N476NAS1

TECHNICAL BULLETIN

SAFETY RECALL: Door Will Not Latch

MODEL:	MODEL YEAR:	VIN:
Range Rover Sport (LW)	2014-2016	001164-620143
Range Rover (LG)	2013-2016	100107-222955

E249343

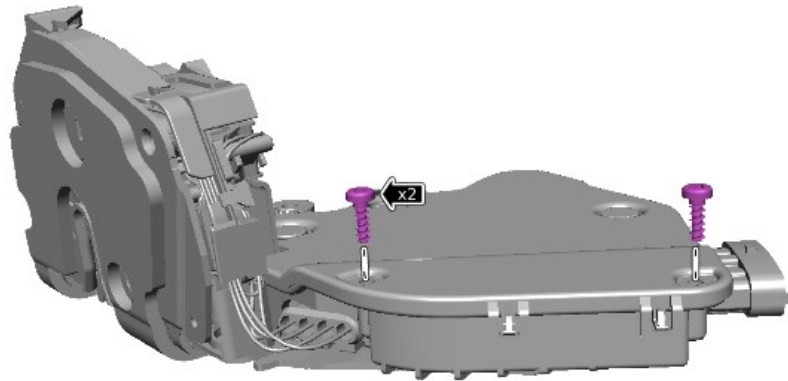
Remove the 2 retaining screws from the door latch cover.

E249345

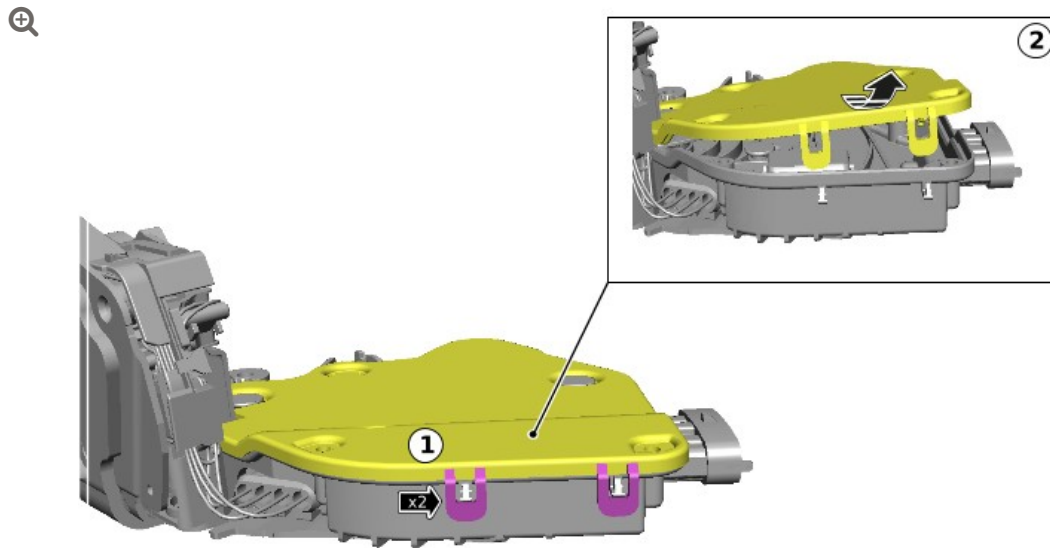
Only reposition the door latch cover; removal of the cover will cause damage to the door latch.

Access the inside of the door latch.

- 1. Release the 2 door latch cover retaining clips.
- 2. Reposition the door latch cover as shown.

E249349

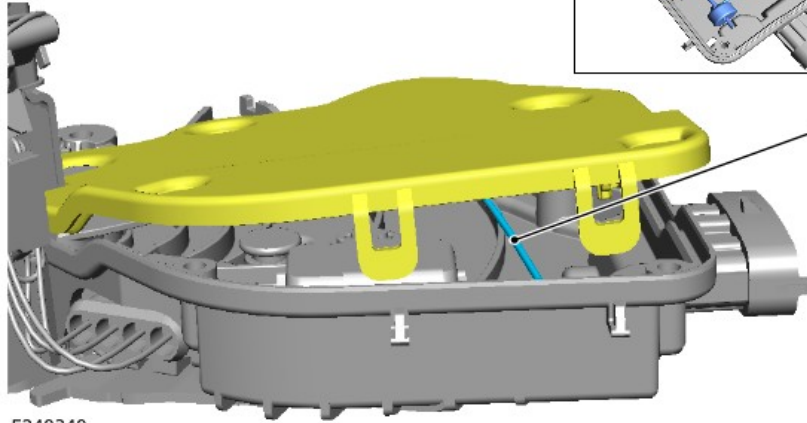
Locate the keyless vehicle motor cord.

E249364

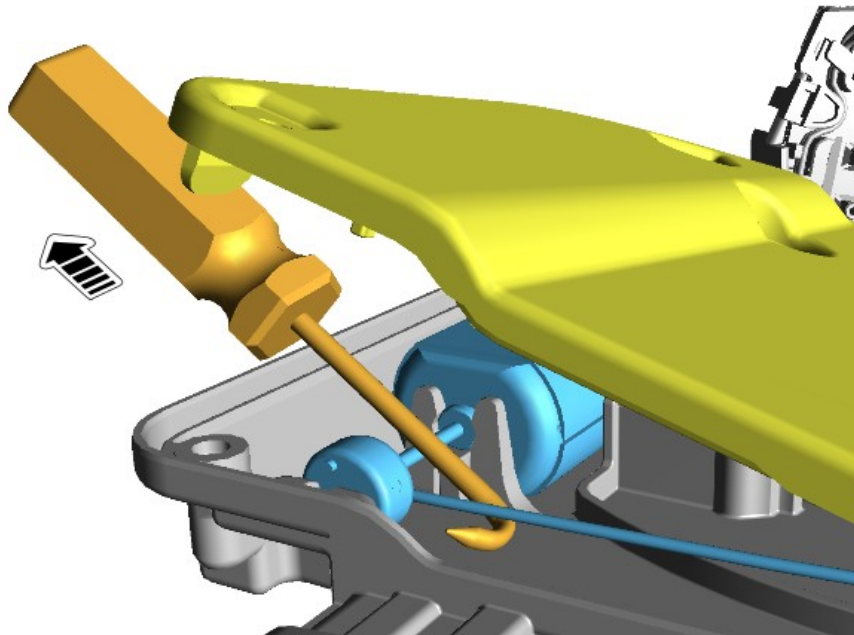
Use a suitable hook tool to pull the keyless vehicle motor cord as far as it will travel.

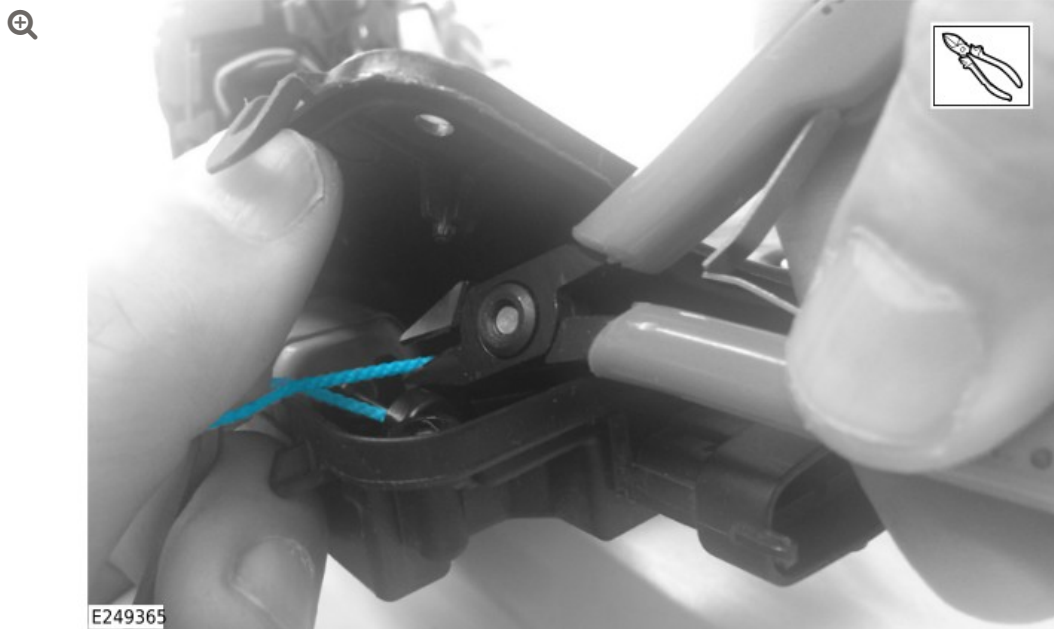
- Allow 40-60 mm of cord from the motor spindle before cutting.
- After cutting the keyless vehicle motor cord, make sure the lever returns back the original position.

Use a suitable tool to cut the keyless vehicle motor cord.

E249348

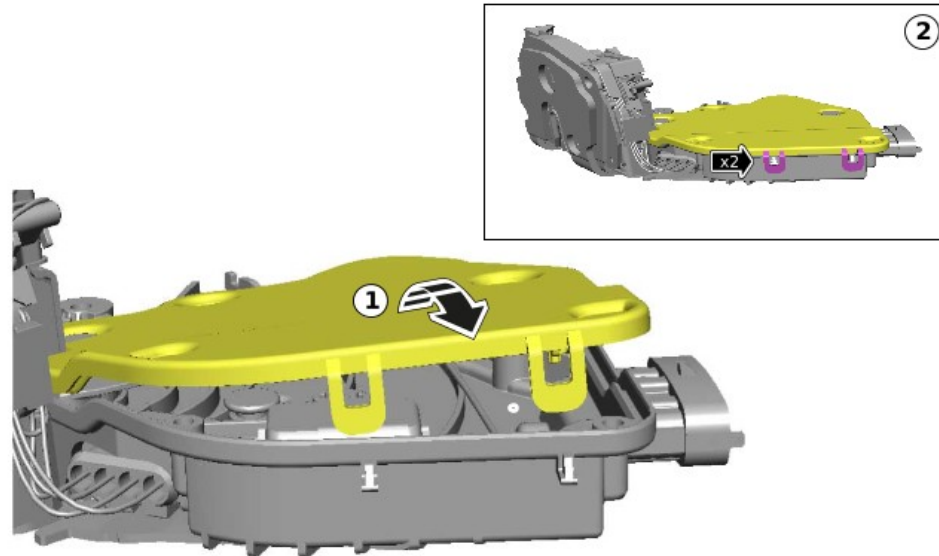
Make sure the excess keyless vehicle motor cord remains inside the door latch housing before installing the door latch cover.

Install the door latch cover.

- 1. Reposition the door latch cover.
- 2. Secure the 2 door latch cover retaining clips.

E249343

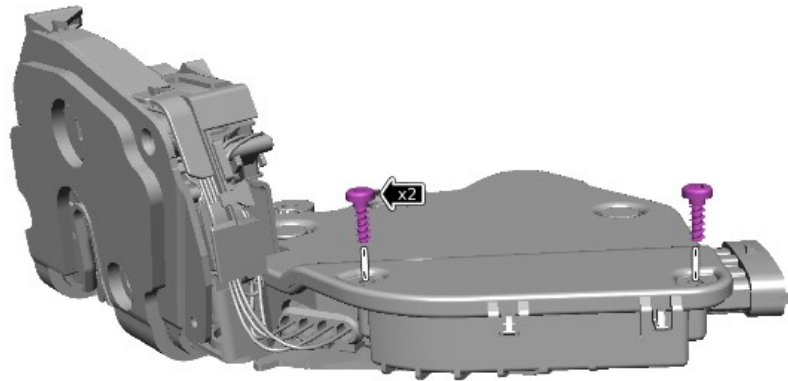
Install the retaining screws.

- Torque: **1.2 Nm**
